Access Compliance Report

Public Rights-of-Way

(Curb Ramps)

Intersection ID: 2454	Main Street: CLARKE_CREEK_PY	Cross Street: MILLSTREAM_RIDGE_DR	Location: NE
ADA ID: B2C66D529CDF	Ramp Type: ParaDiag	Initial Pass/Fail: Fail	Overall Compliance: No
		Severity Score: 37.5

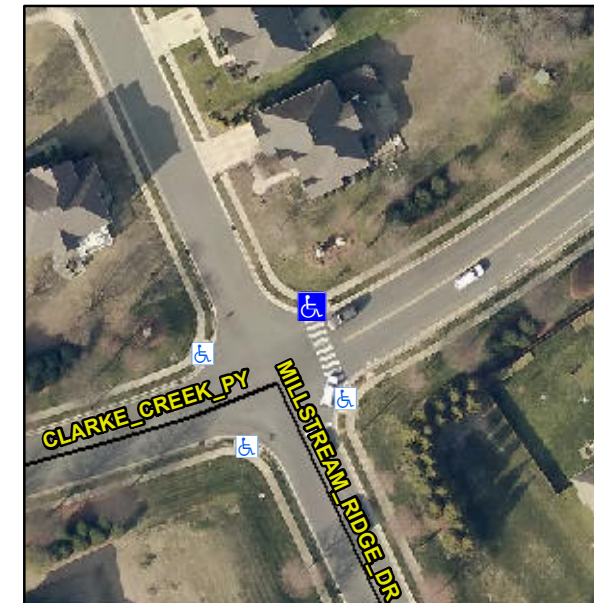
R304.3.2, R304.5.3

Compliance	Description	Data	Compliance	Description	Data
N/A	Ramp Length LT (in)	41.0	N/A	Ramp Length RT (in)	53.0
Yes	Ramp Width LT (in)	48.0	Yes	Ramp Width RT (in)	48.0
No	Ramp Slope LT (%)	10.1	Yes	Ramp Slope RT (%)	5.3
No	Ramp XSlope LT (%)	7.1	Yes	Ramp XSlope RT (%)	1.3
N/A	Landing Length (in)	N/A	N/A	DWS Provided?	N/A
N/A	Landing Width (in)	N/A	N/A	DWS Contrast?	N/A
N/A	Landing Slope (%)	N/A	N/A	DWS Length (in)	N/A
N/A	Landing X Slope (%)	N/A	N/A	DWS Full Width?	N/A
N/A	Landing Curb? (Y/N)	N/A	N/A	DWS Offset (in)	N/A
N/A	Shared Landing?	N/A			
N/A	Gutter Ponding?	N/A	N/A	Gutter Slope (%)	N/A
N/A	Gutter Lip Ht (in)	N/A	N/A	Gutter X Slope (%)	N/A
N/A	Painted X Walk1?	No	N/A	Painted X Walk2?	Yes
	X Walk 1 Direction	To W		X Walk 2 Direction	To S
N/A	X Walk 1 Width (in)	N/A	N/A	X Walk 2 Width (in)	108.0
	X Walk 1 Slope (%)	2.6		X Walk 2 Slope (%)	7.3
	X Walk 1 X Slope (%)	2.6		X Walk 2 X Slope (%)	2.7
N/A	Ramp inside XWalk1?	N/A	N/A	Ramp inside XWalk2?	Yes

Remove & Replace Curb Ramp With Two New Directional Ramps or Equivalent.
